AENC-NG-CNS-REP-0012

Norwich to Tilbury

Document: 5.15 Design Development Report - Tracked
Changes Version

Final Issue B

Figure 4.4 Tas Valley overhead line and construction access alignments

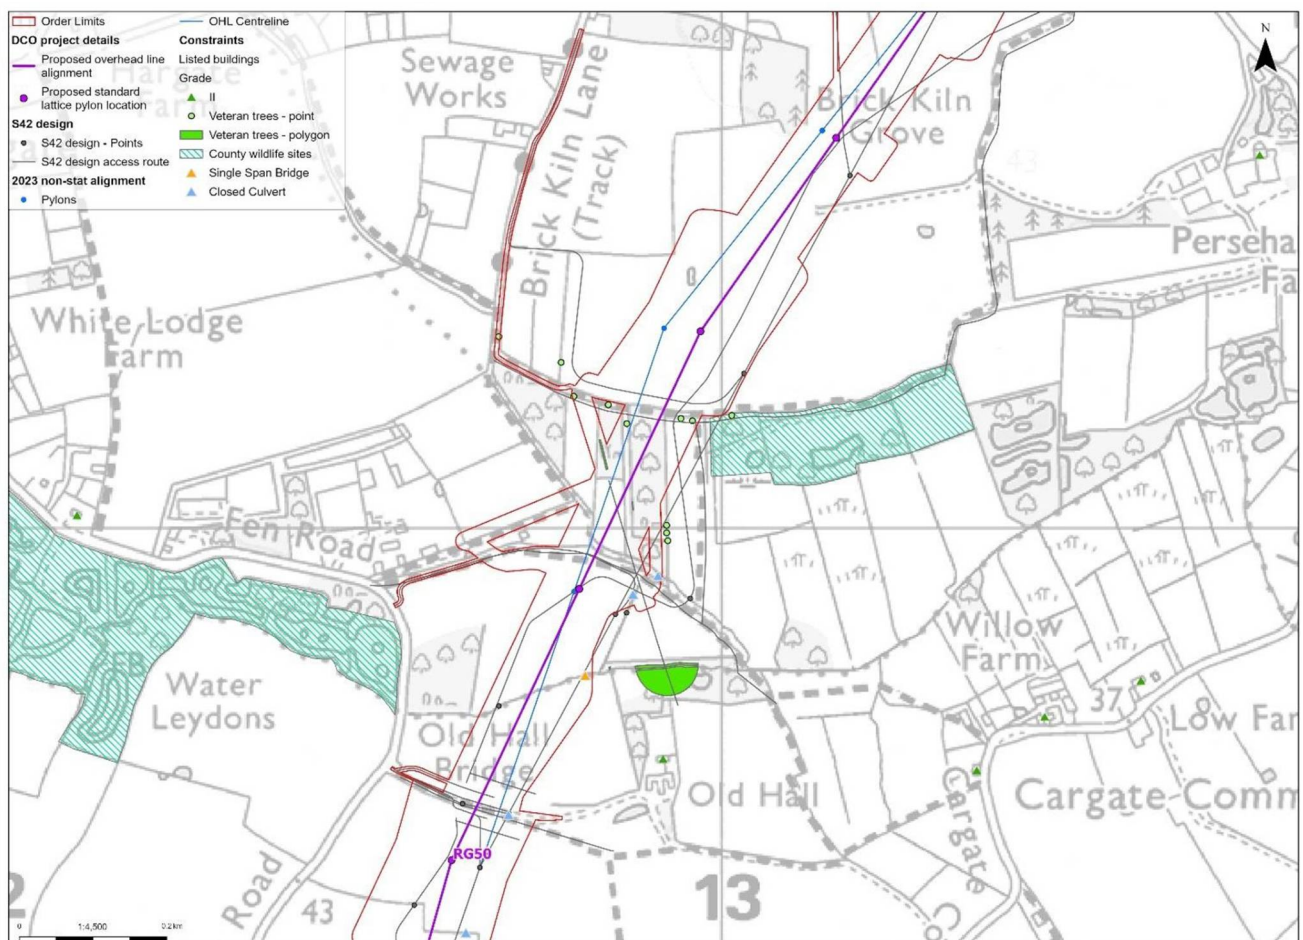
on agricultural cropping without other changes in likely effects and is therefore being taken forward. Other amendments to temporary haul road arrangements have also been considered and taken forward. To the east of [TB48RG48](#) to [TB49RG49](#), the proposal is to use a previously cleared area within the woodland for the haul road to avoid routeing within the open field used for livestock over-wintering. In addition, other specific measures would be adopted to reduce woodland loss including the narrowing of the access road through the woodland and the use of trackway. The remainder of the haul road northwards to RG46 and southwards to RG52 have also been adjusted to predominantly remain to the east of the alignment with all but a short 50 m section remaining within the 2024 draft Order Limits.

- 4.4.6 Similarly, the movement of the alignment has modified the extent to which lower voltage infrastructure modifications are required, and which consequently responds to a change requested in feedback. The change in the alignment requires the 11 kV overhead line to be replaced by underground cable over a different section. It requires less 11 kV removal to the south but more removal to the north. The removal of the wood pole overhead line occurs to the field boundary to the north with the underground cable following alongside field boundaries and the haul road alignment, minimising the need for tree removal.
